200 TO (HK) LTD.
 JOB #: 3482H1
 FCC ID : O4Y10038
 EXHIBIT : 2

TITLE:	10038(49.86MHZ)
P.C.B.	10038
DRAWN:	HO
DATE:	2001-03-28

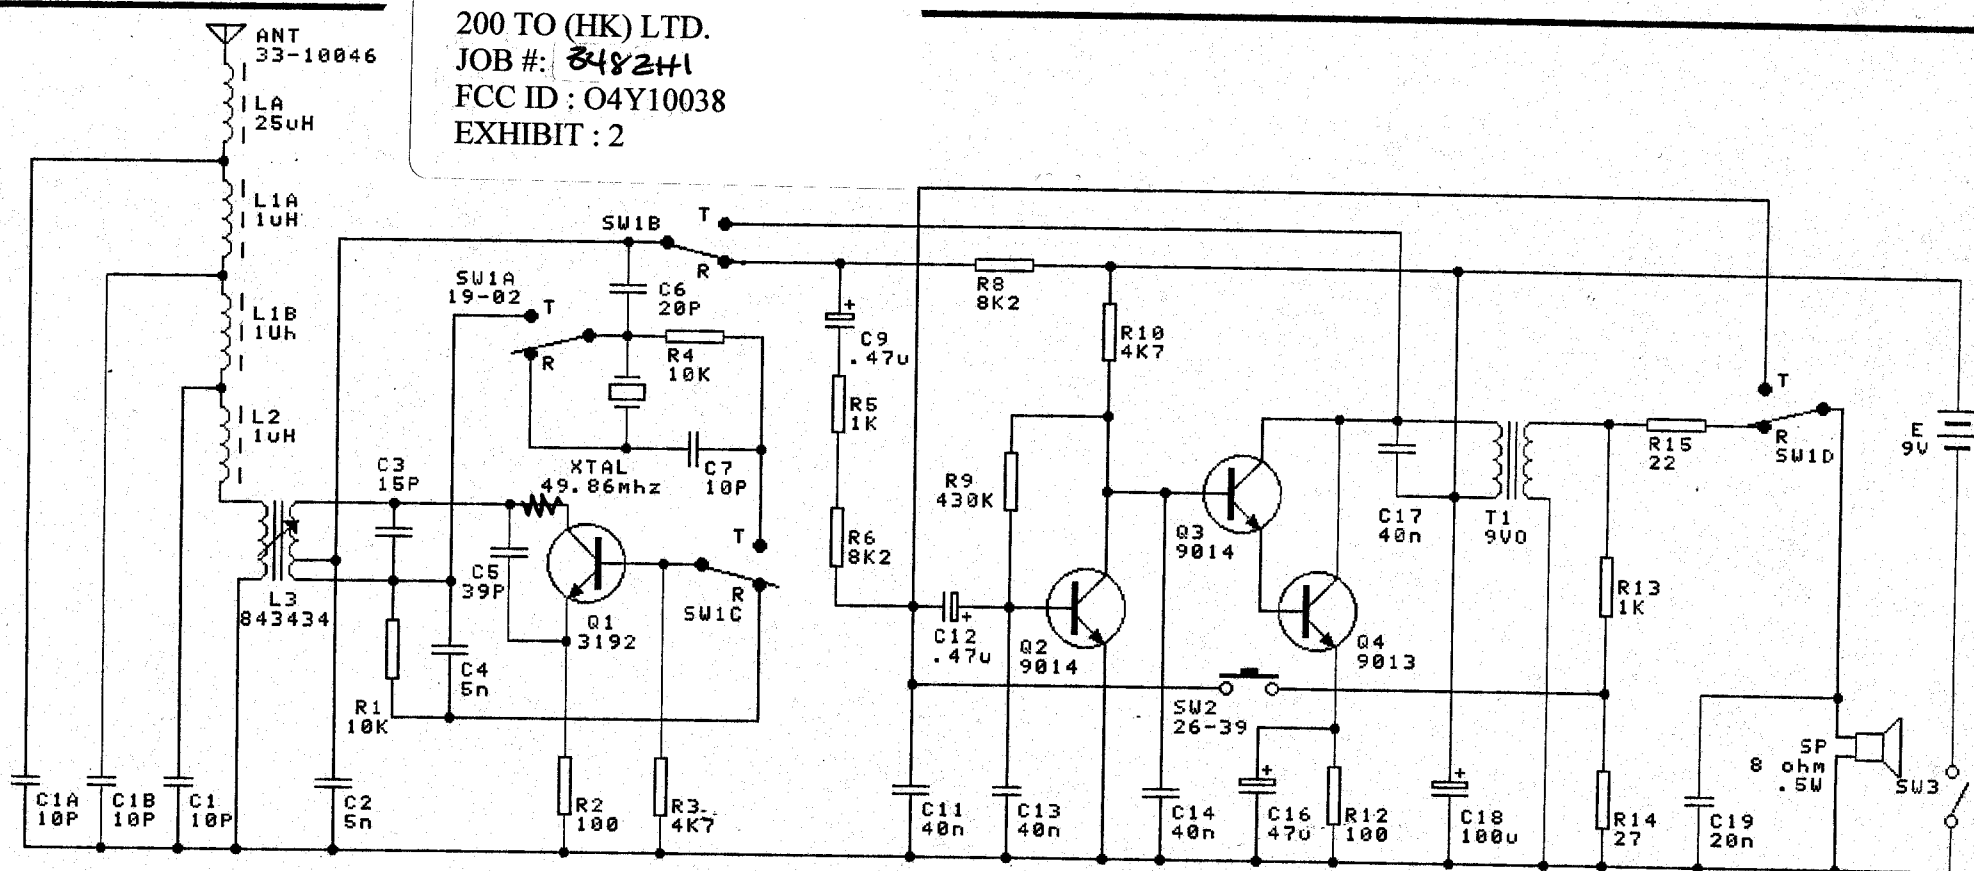
Add 56Ω resistor in series with collector of Q1
